FIELD SERVICE BULLETIN

FSB Number: LVCCFSB2004-113
Author: Max Dekirmandjian
Date: May 21, 2004
Total No. of Pages: 2
Subject: No/Intermittent/Noisy Mic Audio on TA02 GSM Products
Model Affected: C236, C250, C260, C33x, C450, C35x, C370, C380,
Level of Repair: 1

Panasonic vs Hosiden Mics (viewed from contact side)

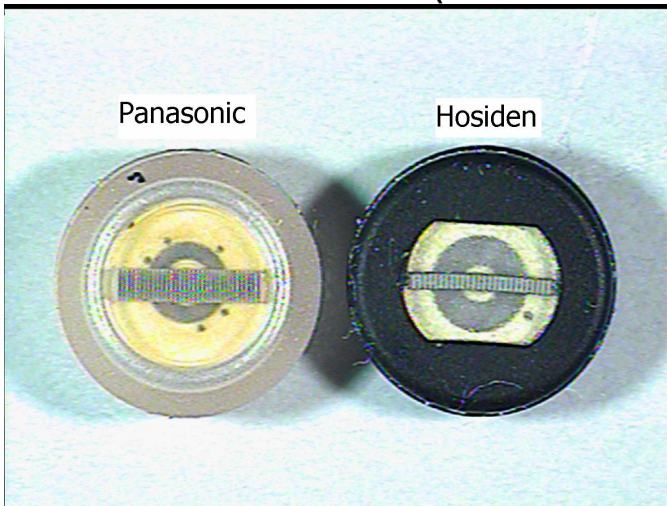
Service has been made aware of an audio issue pertaining to the microphone 5089725K04. There have been customer complaints from the field related to the TX/Mic audio when Panasonic mics are used. This was also confirmed during the C350 MOL analysis. In many cases, proper Mic audio operation can be temporarily restored by applying pressure to the front housing near the mic location. The root cause has been determined to be deformation of the elastomer boot used on the Panasonic mic which results in a no or intermittent connection between the Mic to PCB contacts. Microphones manufactured by Hosiden do not exhibit these failures. The elastomer boot on Hosiden mics is a different design. Compression testing of these microphone assemblies found that the Panasonic mic required a greater load than the Hosiden samples to reach comparable resistances across contacts of a test board.

- 1) Disassemble the unit to gain visibility to the mic
- 2) Verify the type of mic being used. Refer to the photo below to aid in distinguishing between the two mics:
- 3) If a Panasonic mic is being used, replace it with a Hosiden.

Microphones manufactured by Hosiden should be used in place of Panasonic. Part # is 5089725K04.
